Technical Bulletin

Bulletin No: TCH-001-051

Subject: BA-921 COMPRESSOR UNLOADER CAP REPLACEMENT KIT

Figure 1:
BA-921 Unloader
Cap
Replacement -
Expanded View

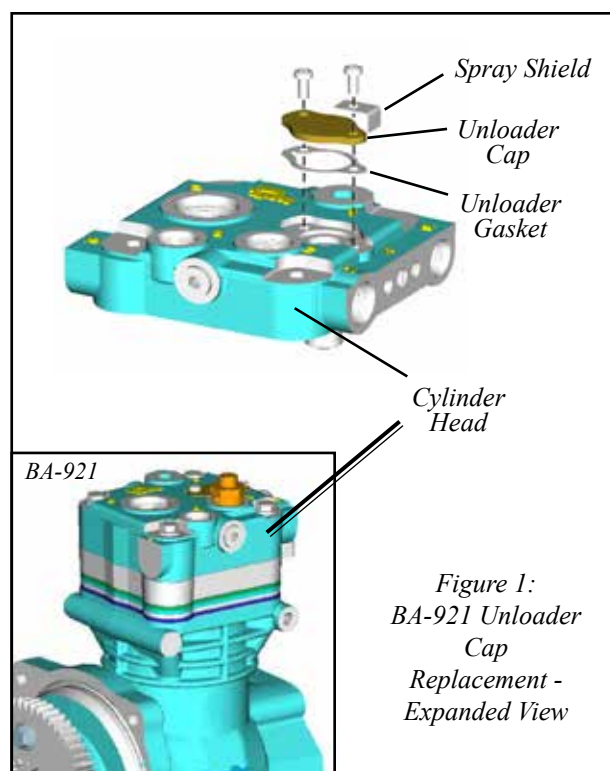
Bendix Commercial Vehicle Systems has determined that for some* BA-921 air compressors, under certain conditions, air pressure can collect above the unloader piston. This prevents the compressor from returning to the unloaded mode, causing it to constantly build air. Bendix has determined that this condition is not safety related.

To guard against this occurring, Bendix has developed a replacement unloader cap designed to prevent air being retained above the unloader piston. Bendix recommends that all BA-921 air compressors listed at the bottom of this page have the replacement unloader cap kit installed.

Detroit Diesel Corp. and Caterpillar Inc. will be conducting a service campaign where authorized DDC and CAT service centers will offer unloader cap replacement kits. The kits, Bendix part number 5012771, contain an unloader cap, unloader gasket and spray shield (see Figure 1) along with installation instructions. Replacement should take less than 20 minutes to complete.

Where a **spray shield** is already installed, the unloader cap upgrade has already been made, and **no action is needed**. Only the BA-921 compressors listed below are part of this service campaign.
